Contract #: 04-0120F4Cty: SF/ALA Rte: 80 PM: 13.2/13.9File #: 69.25B**QUALITY ASSURANCE -- NON-CONFORMANCE REPORT****Location:** Changxing Island, Shanghai, P. R. China**Report No:** NCR-000474**Prime Contractor:** American Bridge/Fluor Enterprises, a JV**Date:** 09-Oct-2009**Submitting Contractor:** Zhenhua Port Machinery Company, Ltd (ZPMC), Changxing Island**NCR #:** ZPMC-0447**Type of problem:**

Reference Description: Missed MT Indications by QC on OBG Segment 1AW/1BW Transverse Splice**Description of Non-Conformance:**

Dear: Mr. Charles Kanapicki
Job Name: SAS Superstructure

Subject: NCR No. ZPMC-0447

Transverse Weld Splice OBW1A-007

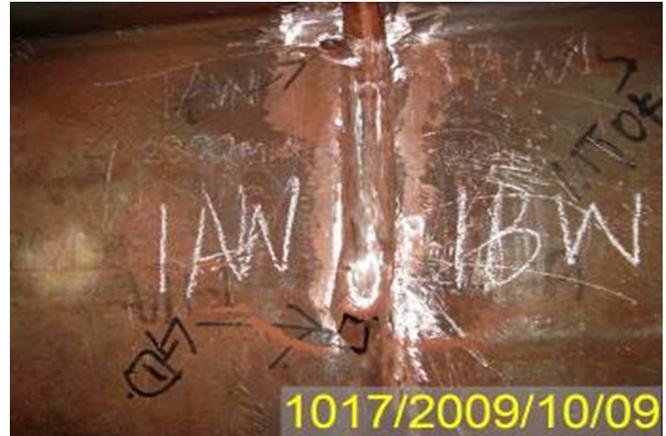
During a random visual inspection of repair work located at 1AW to 1BW side panel segment transverse splice weld OBW1A-007, the Caltrans Quality Assurance (QA) Inspector observed ZPMC workers performing repair excavations at two (2) separate areas along this weld splice. The QA Inspector performed Magnetic Particle testing (MT) at the excavated areas that had been previously tested and accepted by ZPMC MT technician. This QA inspector observed seven (7) Transverse Cracks present in the 2 excavation areas. The submitted critical weld repair procedure (CWR) for this location has not been approved by the Engineer prior to the repair work being started. The Y locations, length of excavated area and number of Transverse Cracks are as followed:

1. Y location 150mm, length of excavation 2,400mm, one (1) indication verified.
2. Y location 760~920mm, length of excavation 2,400mm, three (3) indications verified.
3. Y location 2,650mm, length of excavation 2,300mm, one (1) indication verified.
4. Y location 2,800mm, length of excavation 2,300mm, one (1) indication verified (in 1AW base metal).
5. Y location 3,400mm, length of excavation 2,300mm, one (1) indication verified.
6. Y location 4,600mm, length of excavation 2,300mm, one (1) indication verified.

Note: Measurements were pulled from the Bottom Plate to Side Plate weld joint at W3.

Submit a repair procedure for the approval of the engineer. Do not start weld repair until the CWR has been approved by the engineer. Missed MT indications have become a chronic problem. Provide training and tests to verify MT technician competency.

Reference Description: Missed MT Transverse Indications by QC on The Side Panel Segment Splice at 1AAW/1AW

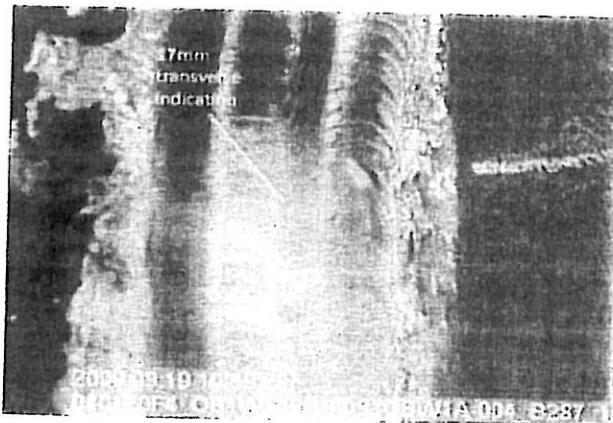
The Quality Assurance (QA) Inspector observed on Sept 18, 2009 and Sept 19, 2009 three (3) visual Transverse Linear Indications in the repair gouges of weld OBW1A-004 (1AAW to 1AW Side Panel Splice at the crossbeam side). The indications were located and documented at Y locations of 5842mm, 6165mm and 6520mm respectively. These visual Transverse Indications were measured from the weld of the Bottom Panel to Side Panel progressing toward the Edge Panel. Subsequently, ZPMC QC performed MT and confirmed that these are transverse indications. This weld joint had been previously tested and accepted by ZPMC QC NDT department.

AWS D1.5 (02) Section 6.26.1.1 "The weld shall have no cracks"

Propose a resolution for the identified recurring non-conformance which constitutes a systematic problem on both materials/workmanship and quality control issues with revised procedures to remedy the defected work and to prevent future occurrences. A response for the resolution of this issue is expected within 14 days.

Component: 1AW to 1BW Weld #OBW1A-007

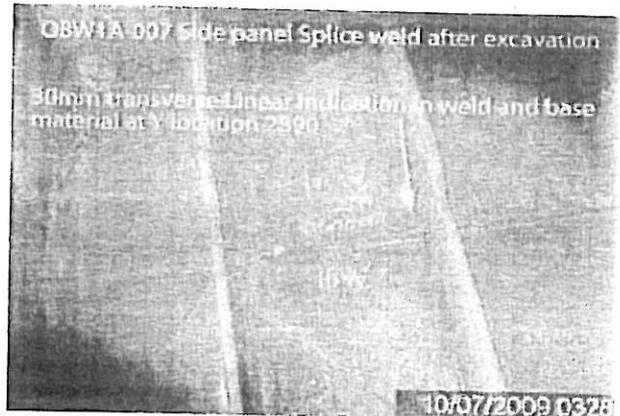
During a random visual observation of ZPMC personnel performing air carbon arc gouging of segment 1AW to 1BW Side Panel transverse splice weld OBW1A-007 at the Counterweight side, the Caltrans Quality Assurance (QA) inspector observed ZPMC was performing this repair utilizing the weld repair report (B-WR8086). This weld repair report did not describe any magnetic particle testing (MT) verifications in the excavation prior to re-welding nor after the completion of welding to ensure that the joint is free of defects. The QA Inspector had the opportunity to perform MT after air carbon arc gouging and observed numerous transverse cracks present ranging from 2 mm to 30 mm in length. No Critical Weld Repair Report was obtained for this weld repair.

The Y locations and the number of Transverse Cracks observed in weld # OBW1A-007:

- 1) Y=50~2475mm, (14) Transverse Cracks
- 2) Y=2720~5030mm, (29) Transverse Cracks

Note: Y location taken from Bottom Panel to Side Panel splice weld at the Counterweight side.

Component: 1AAW to 1AW Deck Panel Weld Splice OBW1-001

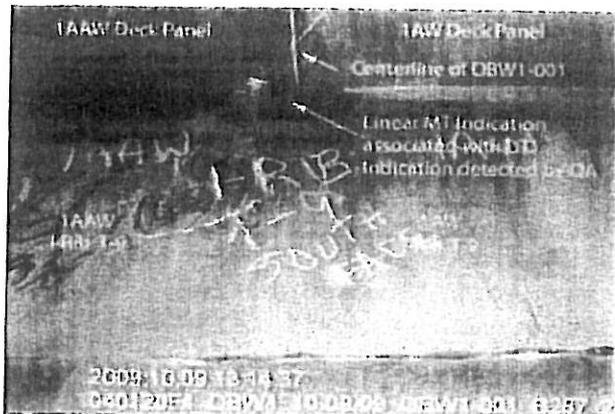
The QA inspector discovered one (1) class "A" rejectable Longitudinal Linear indication in the OBW1-001 (deck panel) weld. This weld was previously tested and accepted by the contractor. This acceptance by the contractor is evident by the presence of the contractor's distinguishing mark indicating QC acceptance. The QA inspector was also able to verify this UT longitudinal indication by magnetic particle (MT) testing from the interior side of the splice weld.

NOTE: The Y location of the Class "A" rejectable Longitudinal Linear Crack is at 5310-5340mm measured from Point W1, or 19750-19780mm if measured from W6. This indication is identified as #25 on ZPMC UT Report B787-UT-8548-1 associated with B-WR7867. The QA inspector verified a 40mm Magnetic Particle (MT) Linear Crack from the interior surface that is associated with Class "A" UT" Rejectable Indication mentioned above.

Submit a repair procedure to the engineer for approval.

Component: 1AW to 1AAW Side Panel Splice Weld OBW1A-00

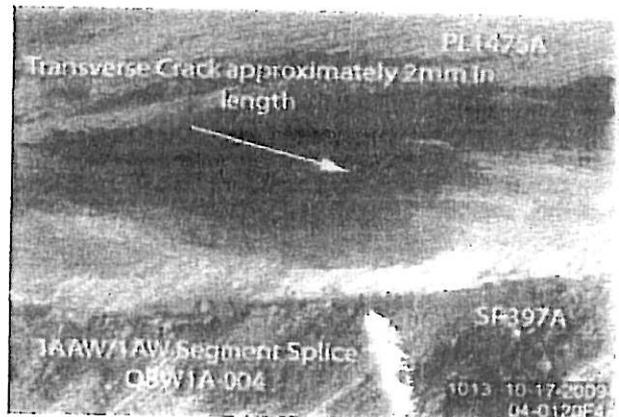
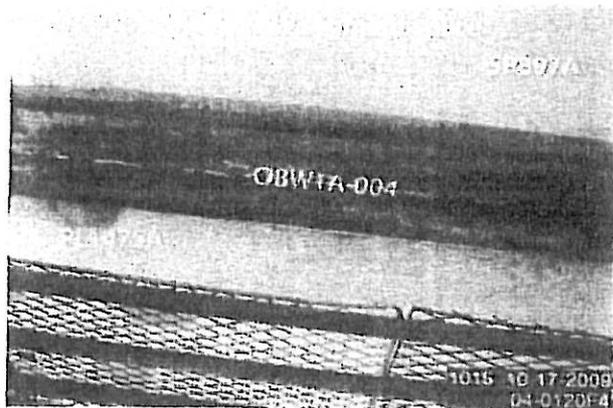
During random visual inspection the QA Inspector performed Magnetic Particle Testing (MT) of an Ultrasonic Testing (UT) reject excavation in the segment CJP Side Plate splice (OBW1A-004), cross beam side joining SP397A (1AW) and PL1475A (1AAW). During this verification the QA Inspector discovered three (3) Transverse Cracks in the excavation. One (1) 2 mm crack was located at Y location 1945mm and two (2) 1mm cracks at Y location 2785mm from the cross beam side Edge Plate.

Submit a repair procedure to the engineer for approval.
